Access Compliance Report Public Rights-of-Way (Curb Ramps)

Main Street: WELDON_HEIGHTS		Cross Street: FLINTRIDGE_AVE		Location:	SE
ADA ID: RPRK211108121139	Ramp Type: Type 4 - Parallel	Initial Pass/Fail: Fail	Overall Compliance: No	Severity Score:	2
Codes/Mitigation Info/Possible Solution			Field Measurements/Component Compliance

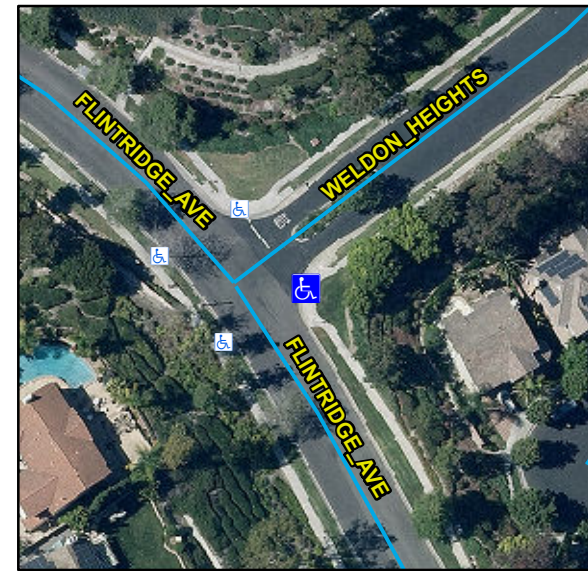
Compliance	Description	Data	Compliance	Description	Data
N/A	Ramp Length LT (in)	112	N/A	Ramp Length RT (in)	114
Yes	Ramp Width LT (in)	90	Yes	Ramp Width RT (in)	90
Yes	Ramp Run Slope LT (%)	5.4	Yes	Ramp Run Slope RT (%)	1.7
Yes	Ramp Cross Slope LT (%)	2	No	Ramp Cross Slope RT (%)	2.1
N/A	Landing Present	N/A	N/A	DWS Provided	N/A
N/A	Landing Length (in)	N/A	N/A	DWS Contrast	N/A
N/A	Landing Width (in)	N/A	N/A	DWS Length (in)	N/A
N/A	Landing Run Slope (%)	N/A	N/A	DWS Full Width	N/A
N/A	Landing Cross Slope (%)	N/A		DWS Offset Type	N/A
N/A	Landing Movement Obstructed?	N/A	N/A	DWS Offset Left (in)	N/A
	Landing Movement Type	N/A	N/A	DWS Offset Right (in)	N/A
N/A	Landing Shared	N/A			
N/A	Clear Space	Yes			
N/A	Clear Space To Crosswalk (in)	N/A			
N/A	Marked Crosswalk 1	No	N/A	Marked Crosswalk 2	No
	Crossing 1 Direction	N		Crossing 2 Direction	W
	Marked Crosswalk 1 Width (in)	N/A		Marked Crosswalk 2 Width (in)	N/A

N/A	Ramp Inside Crosswalk 1	N/A	N/A	Ramp Inside Crosswalk 2	N/A
	Crossing 1 Slope (%)	5.1		Crossing 2 Slope (%)	3.2
	Crossing 1 Cross Slope (%)	3.3		Crossing 2 Cross Slope (%)	4.3
N/A	Gutter Ponding	N/A	No	Curb Slope	12.1
Yes	Gutter Lip Height (in)	0		Road Run Slope (%)	3.6
N/A	Gutter Run Slope (%)	N/A		Road Cross Slope (%)	3.8
N/A	Gutter Cross Slope (%)	N/A	No	Perpendicular Joint Present	No
Yes	Overall Surface Condition	Acceptable			
	Cross Gutter Present?	No		Spandrel Present?	No
	Replace Cross Gutter?	N/A		Replace Spandrel?	N/A

Remove & Replace Curb Ramp With Two New Directional Ramps or Equivalent.

R304.2.2, R204.3, R304.5.3, STD 1115
